RE: CEC Preliminary Water Supply Analysis - Hydrogen Energy of California

The purpose of this letter is to provide BVWSD's response to the Preliminary Water Supply Analysis prepared by CEC staff. This Preliminary Analysis was the subject of a CEC Staff Workshop on February 20, 2013 on the HECA Amended Application for Certification. This response is in the form of two memorandum's prepared by district consultants. Dan Bartel, PE, was employed by the District for over 19 years prior to becoming its consultant and Bob Crewdson, PhD., has consulted to the district for 10 consecutive years.

Subject: Comments on the CEC Preliminary Water Supply Analysis of January, 2012, authored by Mike Conway, John Fio, and Steve Deverel, in regard to the BVWSD proposed well field and water supply for the HECA power plant project.

Soil and Water Figure 7. Simulated 25-year drawdown from staff-modified model including reduced storativity (0.007) and anisotropy increased to 1,000.

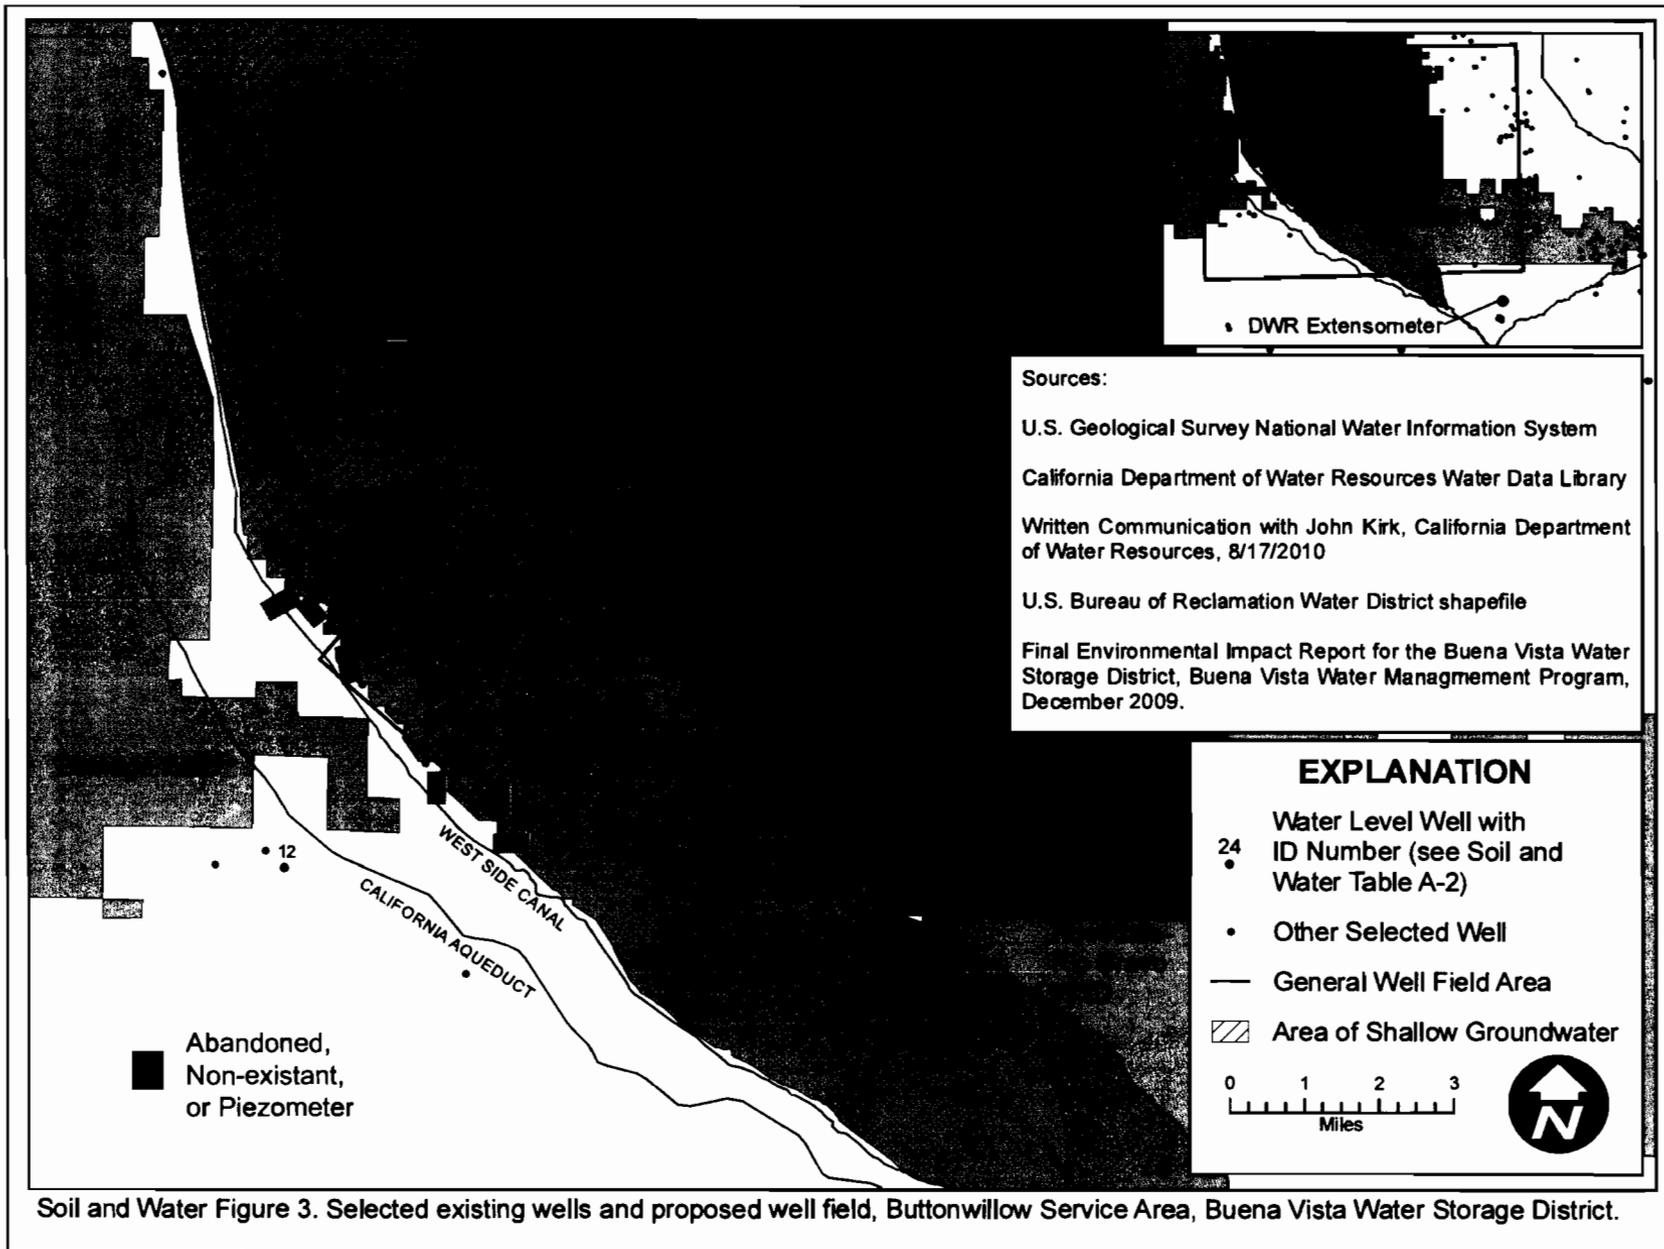
4. Boundary conditions. The CEC conceptualization which requires the placement of no- flow boundaries 6 miles west, 5 miles north, 17 miles south, and unspecified miles east of the well field³ is acceptable. However, the final drawdown contour maps do not reflect these changes to the model construction. The CEC 25-year water level drawdown maps (PWSA, S&W Figures 5 - 7) show the expected no-flow water level behavior only on the west boundary, but not at the north and east boundary locations (the maps do not extend far enough south to show the south boundary. I conclude that the discrepancies between the preliminary text and figures need to be addressed in such a way that both the conceptualization and the final calculated/ illustrated results agree with the district conditions.

5. Storage coefficient. The CEC model conceptualization (PWSA, p. 6.9-11) does not correctly represent the aquifer in the project area. The drawdowns from local wells which are completed in varying intervals down to about 600 ft respond as if completed in an unconfined aquifer, so this is the representation that the model should provide. From theoretical considerations alone, the late-time behavior of the modeled wells should be a function of gravity drainage governed by specific yield (Sy) and not a function of elastic release governed by specific storage (Ss), especially after 25 years of continuous pumping. Although the CEC staff has not explained how the ModFlow simulator incorporates storage constants into the calculation, I conclude that the staff's representation that "*storativity should therefore be utilized to represent storage properties of the pumped aquifer*" (PWSA, p. 6.9-11) is inapplicable to the project area and should be corrected.

Soil and Water Figure 12. Map showing reported depth to the base of freshwater and TDS concentrations in samples from deep and unknown depth wells.

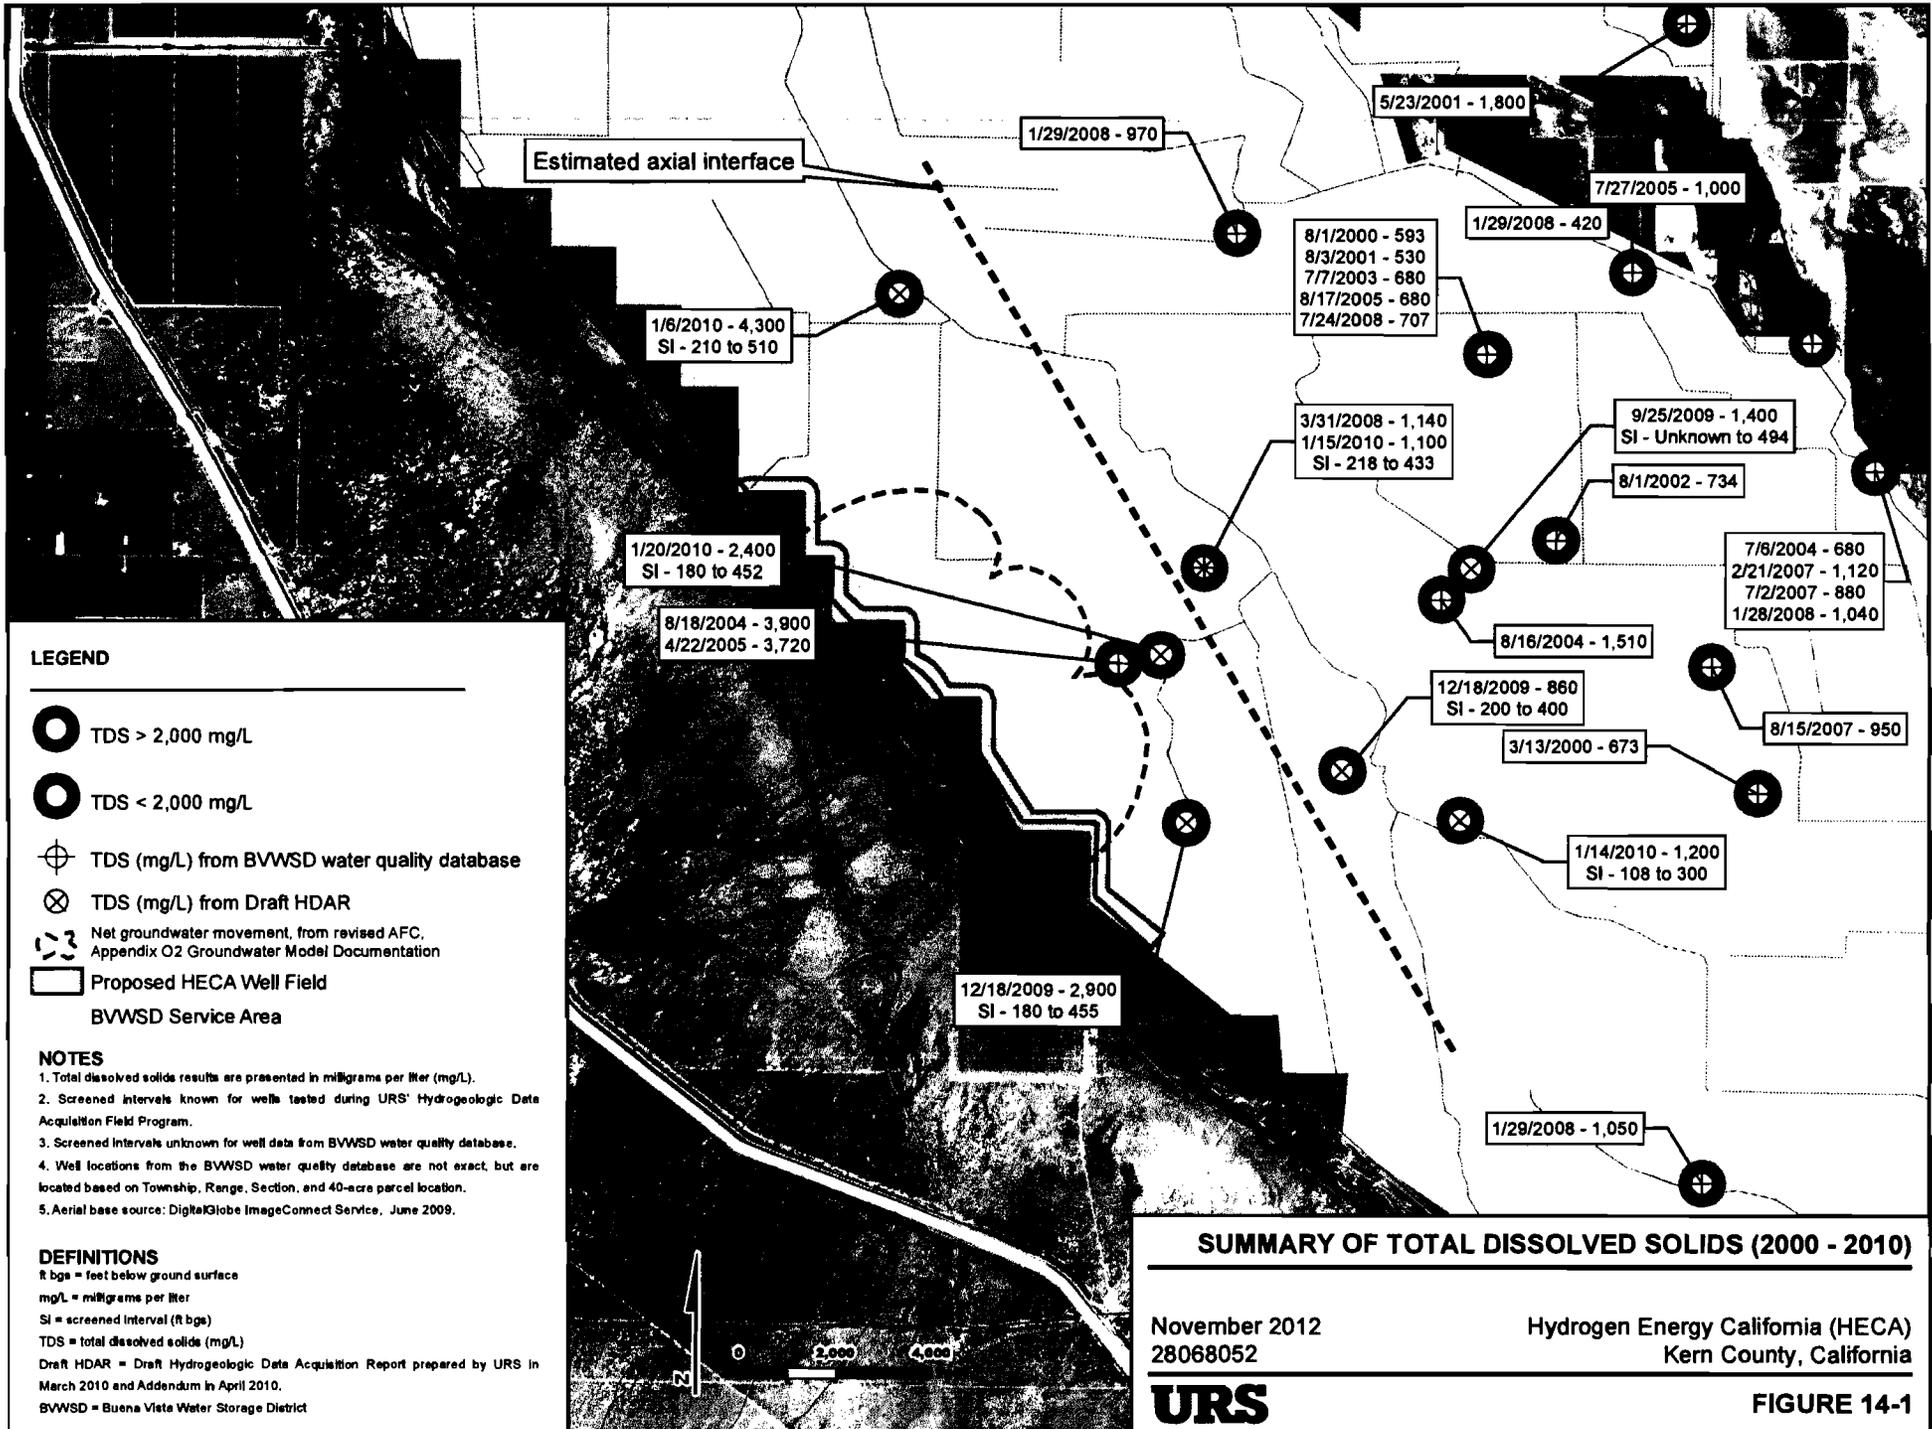
The conclusions relative to potential water quality impacts are largely driven by the use of extremely old groundwater data collected from as early as 1961 as shown on CEC Figure 12 (Attachment 10). The data is valuable in that it depicts what the groundwater conditions were 50+ years ago but should not be confused with current conditions as shown in URS Figure 14-1 (Attachment 11). The local pumpers have documented, by the progressive replacement of their wells from west to the east, the degradation water quality over time on the west side of the BSA. CEC staff appears to incorrectly assume the 1961 data to be current and uses it within blending models to support their position. In regards to a proper environmental analysis we are required to use the most current data available as relying on such outdated data is not consistent with the legal requirements of CEQA. CEC staff has produced figures depicting groundwater contours created by BVWSD and has used this outdated data to discount the validity of said BVWSD information. Contour maps produced by BVWSD were created using the most comprehensive data available with a prioritization of using current data over older data when available. Historically the BVWSD has only published general water quality information so as to protect its ability to collect private data for such purposes. BVWSD could potentially provide said background site specific data to the CEC given confidentiality assurances.
